## **Transport for NSW**

TfNSW reference: STH22/00293/01 Your reference: DA0078/23 (CNR-44274)

DA0078/23 - Erection of new school buildings and alterations to parking and vehicle movement areas - LOT: 1 DP: 1037342 - 61 Train Street BROULEE

Attachment 1

#### Context

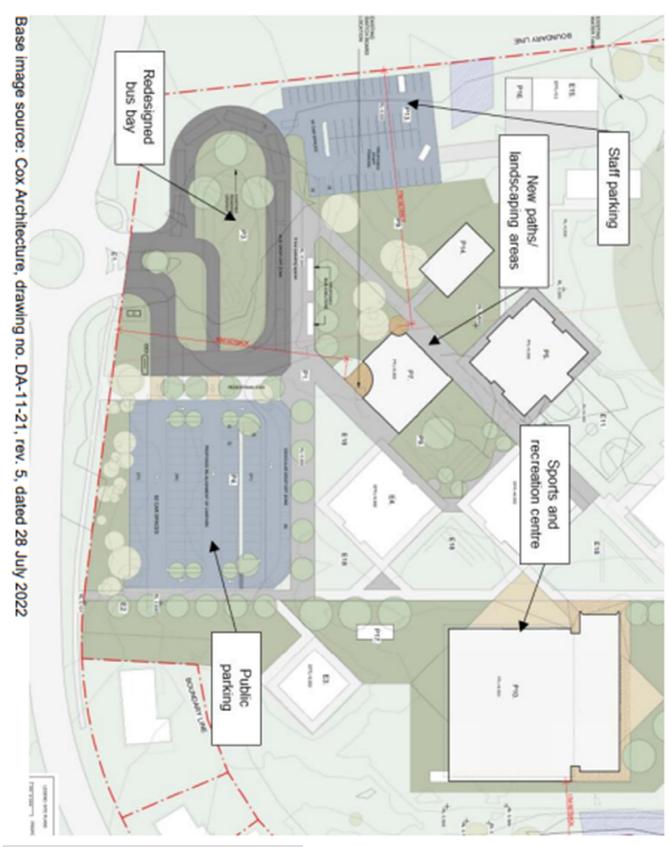
TfNSW notes for this DA:

- The key state road is the Princes Highway. Broulee Road, Tomakin Road, and North Head
  Drive are the closest intersections with the Princes Highway and TfNSW does not believe
  these will be impacted because of the development.

- George Bass Drive is a classified regional road under the management of Eurobodalla Shire Council.
- Council is seeking advice from TfNSW to assist in its assessment under Section 3.58 of State Environmental Planning Policy (Transport and Infrastructure) 2021

- The development proposes erection of new school buildings and alterations to parking and vehicle movement areas as set out in Attachment 2.
- Consultation with the relevant bus operators is still being undertaken regarding the
  proposed increase in student enrolments and changes to the bus pick up and drop off
  zones. Council should be satisfied that appropriate consultation has been undertaken
  and considered to ensure that there are no adverse impacts to the adjacent classified
  road.
